Re: Initial Submission Review - Metro Center Master Plan - Master Plan
Application Number: DA-1489-16
Case Number(s): 2020-7006-00

Initial Submission Review

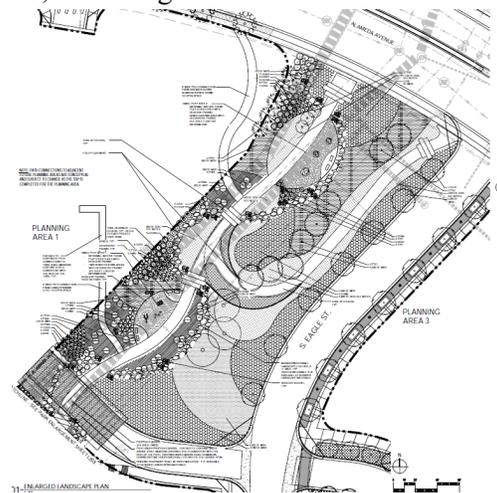
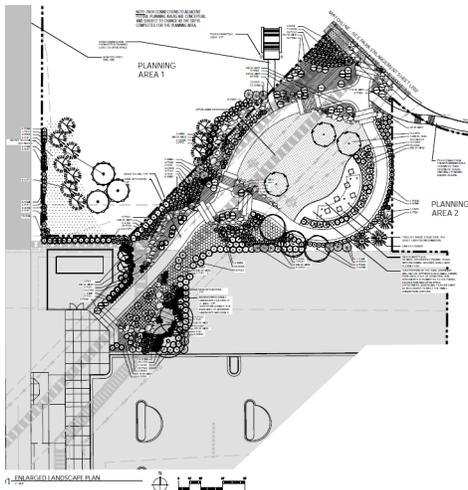
- 9E. The City Center Station Area Plan requires TOD light standards, which are Louis Poulsen pedestrian lighting and gullwing street lights.
- 9F. Street Dedication must accompany any future plat documents.

Pedestrian Lighting: Louis Poulsen
(or similar, to be approved by Planning Director)

Street Light: Gullwing (Molde Street)
